# Updated Leakage Analysis

Industry/EP/NRC/ANL Meeting

11-19-08

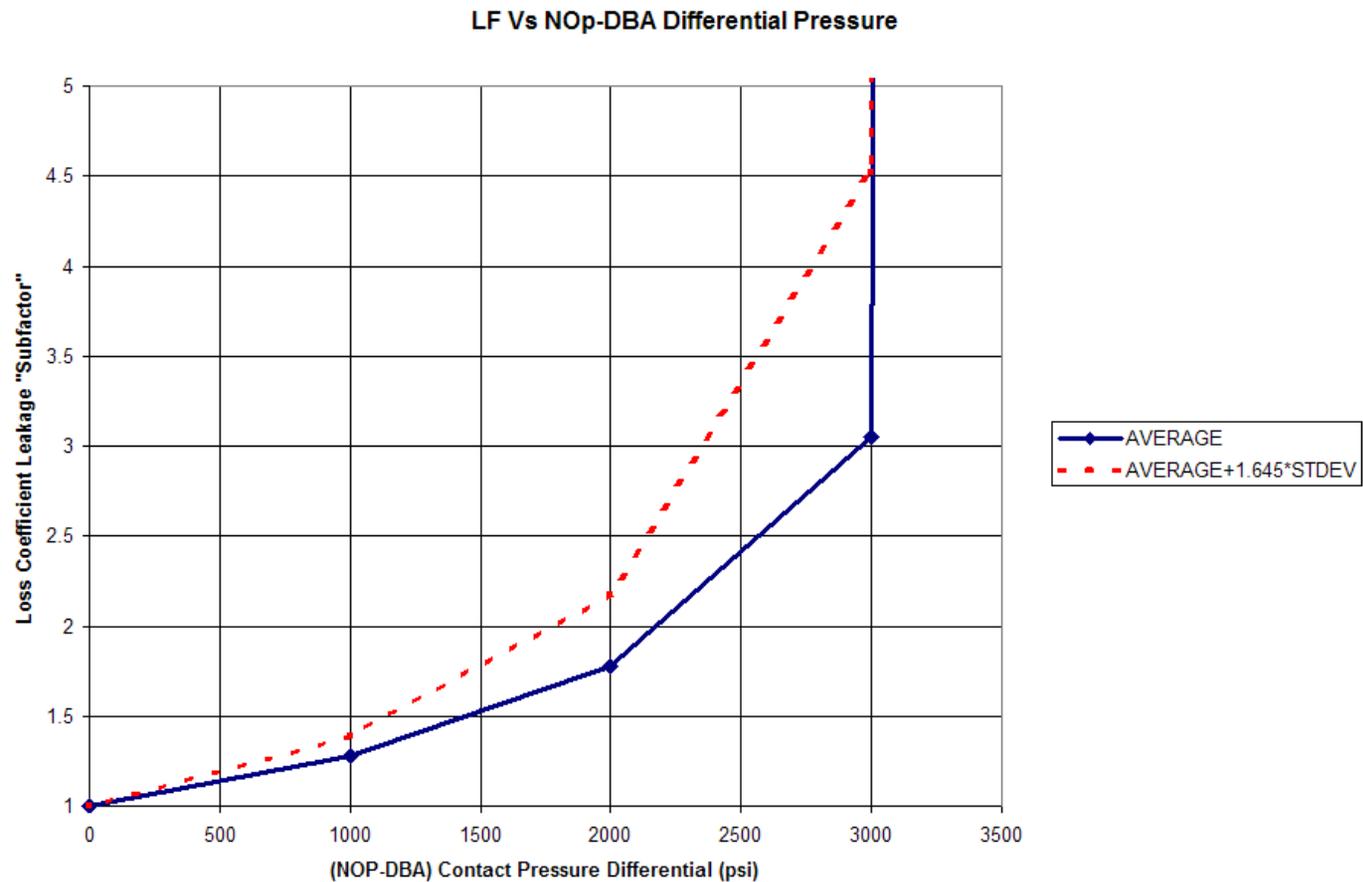
- Addressing concern No. 2, how will the issue that a possible reduction in contact pressure between NOP and DBA conditions can occur be addressed?
  - A “subfactor” for loss coefficient can be conservatively re-introduced into the expression for determining overall leakage factor to address the potential reduction in contact pressure during a design basis accident

$$\frac{Q_{DBA}}{Q_{NOP}} = \frac{\Delta P_{DBA}}{\Delta P_{NOP}} \frac{m_{NOP}}{m_{DBA}} \frac{l_{NOP}}{l_{DBA}} \frac{K_{NOP}}{K_{DBA}}$$
